Staff Report

Oregon State Police Class "C" Variance File No. VAR-22002

January 10, 2023

Item Summary

ATTACHMENT "B-2"

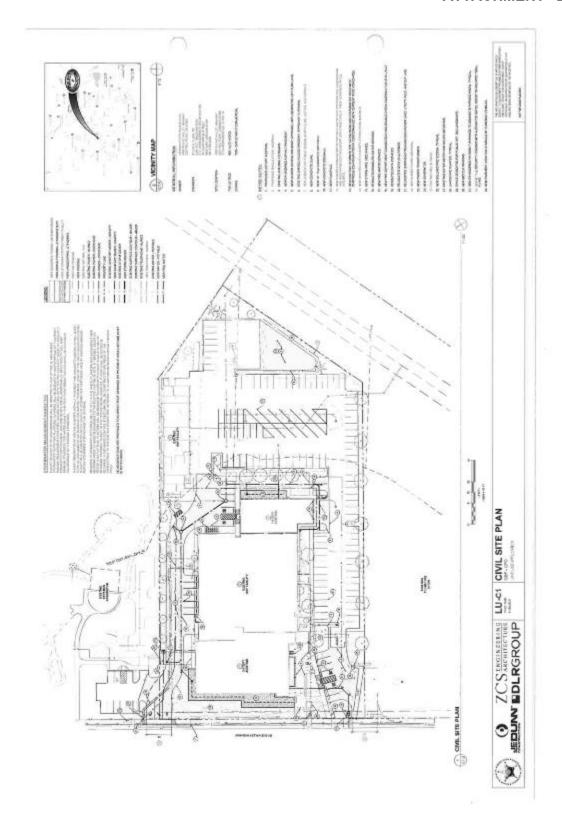
The applicant's engineer has stated in the Applicant's Supplemental Findings (Attachment "D") that the stormwater treatment requirements coupled with the existing systems necessitate the proposed location of the facilities. As shown on the Site and Landscape Plans (Attachment "B-1", B-2", "B-3"), the area needed for stormwater treatment occupies 22-ft necessitating the 33-ft setback.

b. Stormwater Treatment Facilities. The addition of impervious surfaces associated with the new building additions and parking area modifications, require stormwater treatment. As shown on the Civil Site Plan (Attachment "B-2"), the area between the proposed building addition and the street right-of-way is lower than street level. The development proposes to use this area as a collection for runoff and incorporates stormwater management features.

<u>Comment</u>: Based on the Applicant's Findings, the optimal location for the stormwater treatment facility is within the front yard. The proposed stormwater treatment facility is anticipated to occupy at least 22-feet between the front of the building and the right-of-way. Together with landscaping and the 10-ft PUE, the minimum distance needed between the front property line and the building façade is 33-feet as requested.
